TITLE: **PRE-EXISTING USE PERMIT NO. 3AF**
(Gateway Shopping Mall)

PROJECT #: Use Permit No. PEUP3AF Gateway Mall

PROPOSAL: To amend the pre-existing use permit to authorize expansion of the mall by approximately 70,000 square feet with waivers to the Zoning Ordinance to reduce the parking requirement and to increase the building height.

GATEWAY SHOPPING CENTER
SPECIAL USE PERMIT PEUP3AF
LINCOLN, NEBRASKA

G-SP-1

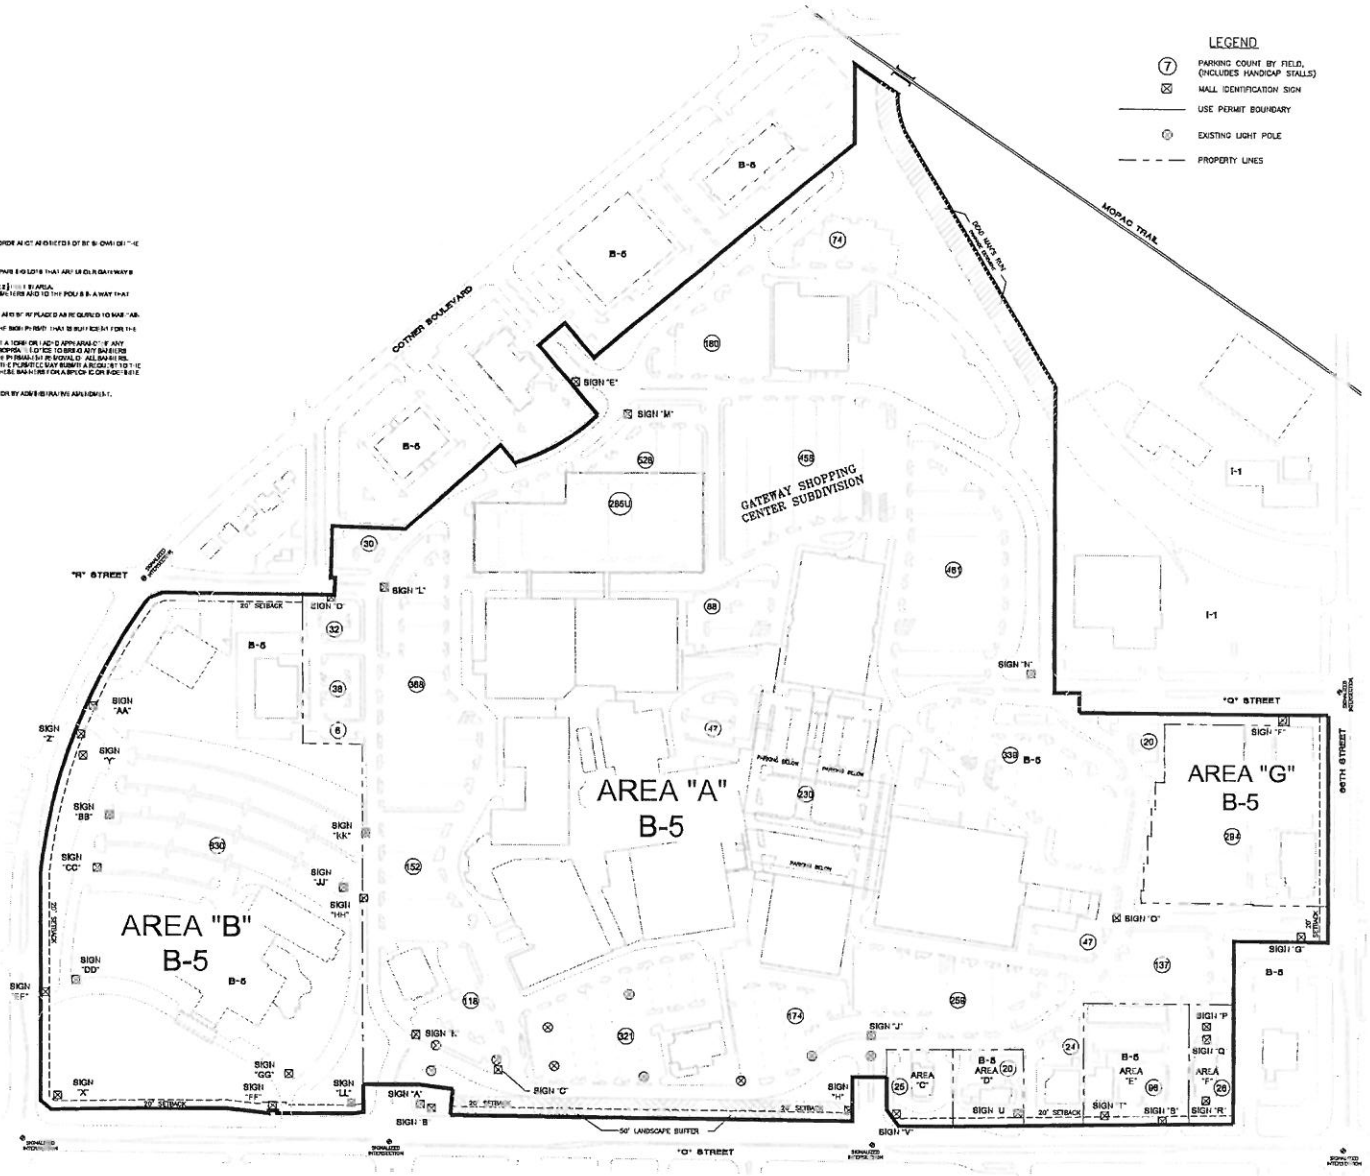
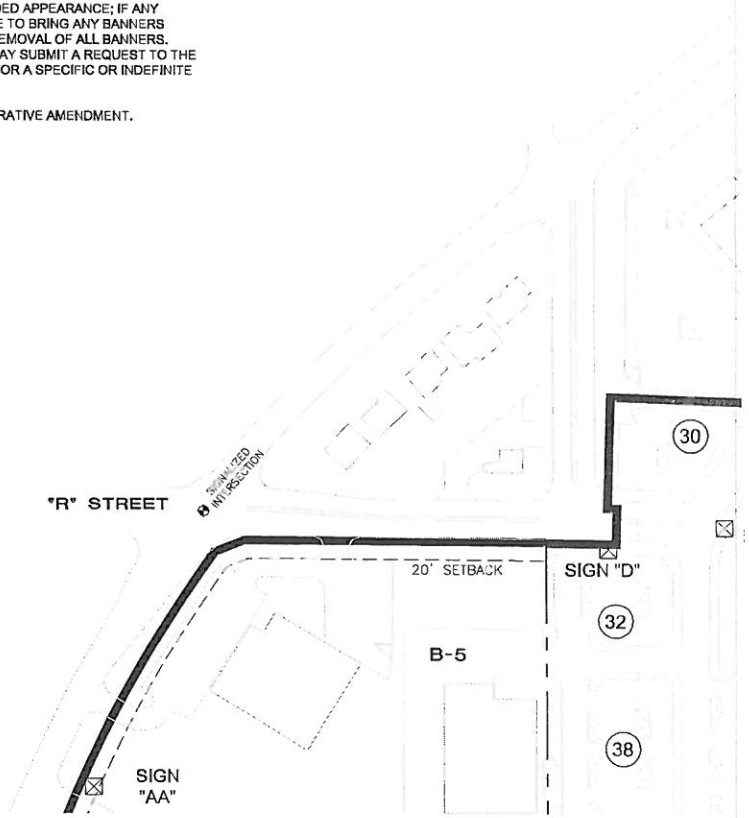
1.1 Add a note to the plan that states, “All terms and conditions of Pre-Existing Use Permit 3 shall apply unless specifically amended by this amendment.”

1.2 Remove Note 9 and Note 3.

1.3 Delete the repeated text in Note 7.

1.4 Update the Sign Inventory table to accurately reflect the sign types.

1.5 Remove the text “Gateway Shopping Center Subdivision” and all zoning labels.

1.6 Label the use permit boundary.

1.7 Remove the third waiver on the site plan.

1.8 Remove the permitted gross floor area from the parking table.

1.9 Revise Note 4 to state, “... 1 space per 300 square feet of gross floor area for all uses.”.

1.10 Revise Note 7©) to state, “The streetscape is not required in Area “A” adjacent to the 50' buffer along O Street as long as the 50' landscape buffer remains.”.

1.11 Add a note to the plan that states, “Signs A & B are located within the public right-of-way. They will be removed from the right-of-way if requested by the Nebraska Department of Roads or if a new center sign is requested at that location. Removing the signs will be done at no cost to the City.”.

1.12 Add text at the end of Note 7 that states, “The requirement to install the streetscape zone may be waived by the Planning Director at the time of building permit.”.

1.14 Revise Note 10 to the satisfaction of the Building & Safety Department.

1.15 Add a note to the plan that states, “Improvements shown on this plan are conceptual and subject to minor changes.”.

1.16 Verify that the numbers provided in the Parking Table on the plan are accurate.

1.17 Add a note to the plan that states, “New signs need not be shown on this site plan, but need to be in compliance with Chapter 27.69 of the Lincoln Zoning Ordinance and must be approved by the Building and Safety Department prior to installation.”
